# Thor Motor Coach Recall Repair Instructions

Recall #	16V-329		
Description/Title:	<b>2017 Venetian, Tuscany, Tuscany XTE Power Loss</b>		
Affected Product Line(s):	<b>Certain 2017 Venetian, Tuscany and Tuscany TXE Units</b>		
Service Campaign # :	<b>RC000114</b>	Released Date:	<b>6.25.16</b>
Failure Code:	<b>TMCRC80449V</b>	Document Date:	<b>6.25.16</b>
Time Allowed:	<b>0.3 hr</b>	Document Revision:	<b>A</b>

New Configuration

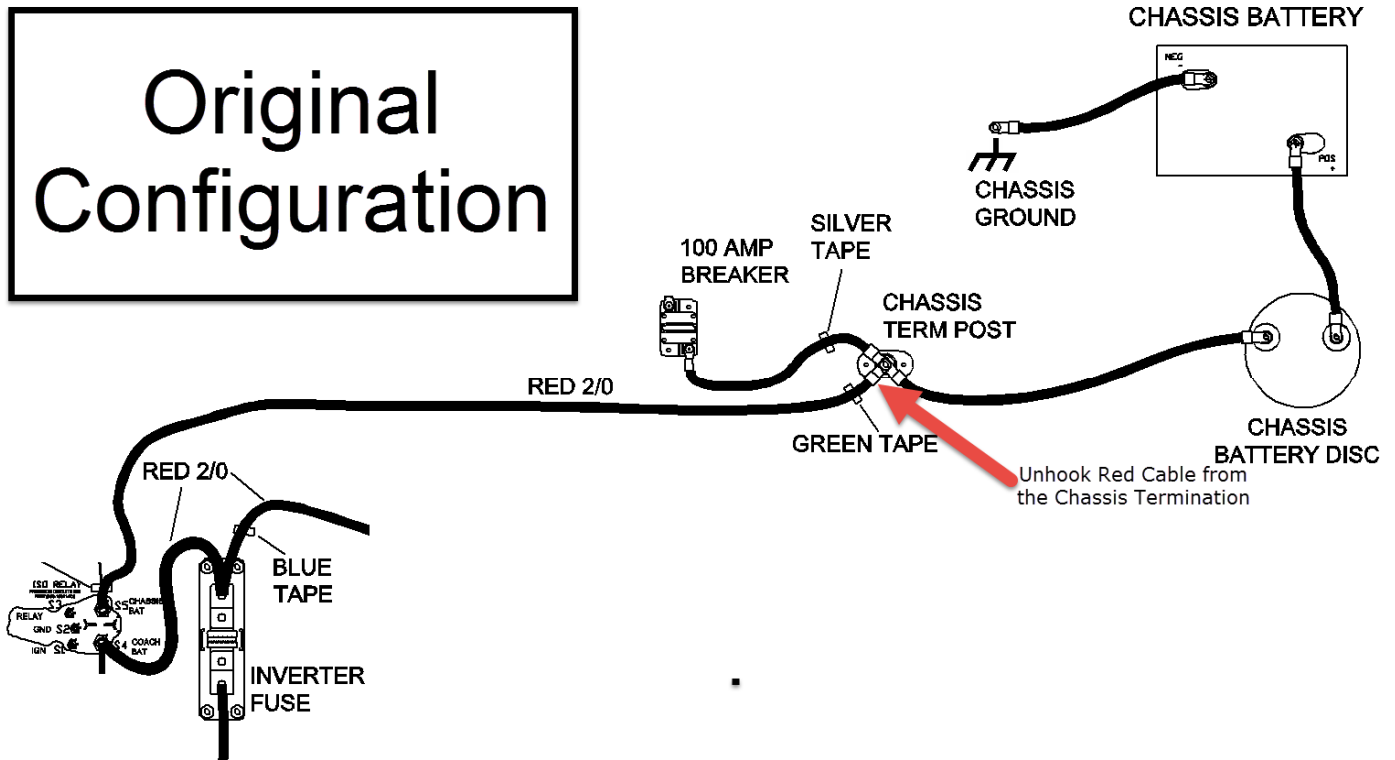
It has been decided that certain TMC Tuscany and Venetian model motorhomes subject to this recall campaign have the isolator relay cable for the chassis battery incorrectly installed. This could cause a sudden unexpected loss of power with the motorhome. If the motorhome is travelling on the road and a loss power occurs, the vehicle operator could experience loss of vehicle control which could result in an accident.

1. Unhook the Red Cable coming from the Isolator Relay.

2. Attach it to the positive post of the Chassis Battery
